**Staff Presentation  
to the  
Historic Preservation  
Commission  
July 20, 2022**

1306 W. Mountain Avenue  
Landmark Design Review – Final Review

# 1306 W Mountain Ave

## Proposed Alterations – Existing Conditions

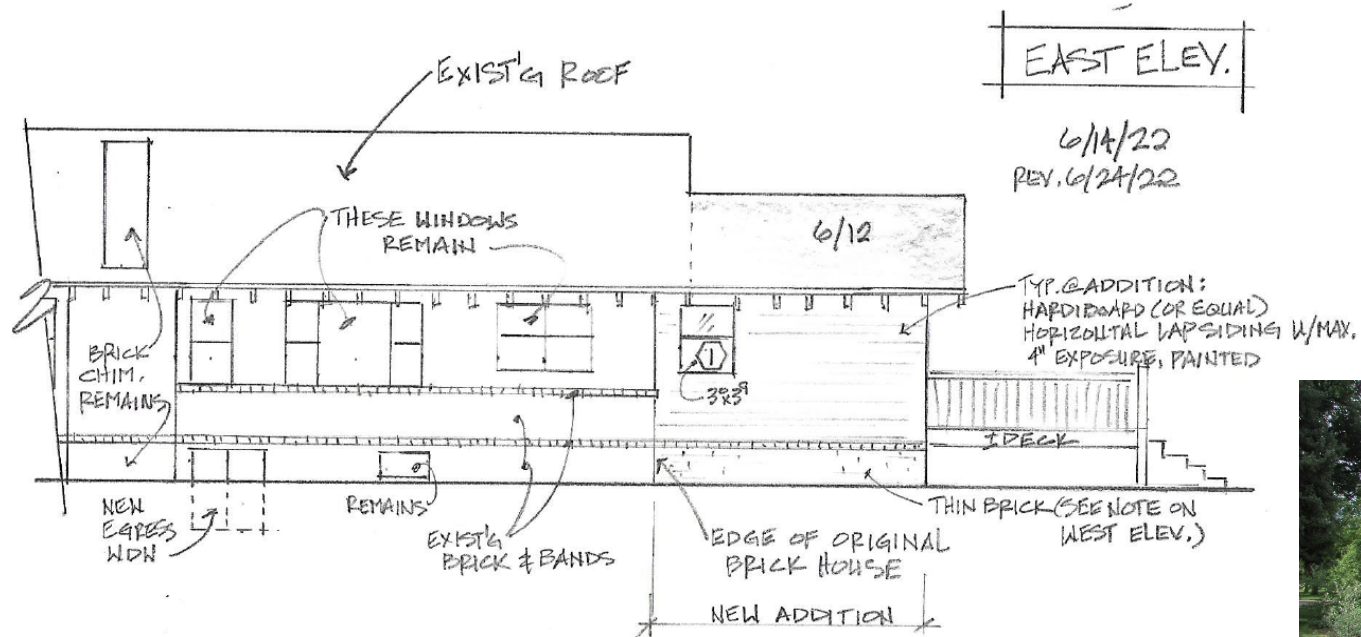
- 2 – Preserve historic character – generally met
  - Addition appears to meet
  - Modifications to northwest bedroom windows not recommended
- Standard 5 – Preserve specific character-defining features and materials – met:
  - Addition begins at rear/north brick wall and is not removing specific historic materials.
  - Again, northwest window treatment not recommended

- 9 – Additions/exterior alterations should be compatible, distinguishable, and subordinate – met
  - Addition is appears to meet all three factors
- 10 – Additions/exterior alterations should be reversible – met:
  - Addition is utilizing existing openings to create connections

- Approve w/ Conditions
  - Condition: to retain the existing west-facing wall in the northwest bedroom, delete one or both of the two proposed new window openings, and install an egress-compliant window in the existing opening.
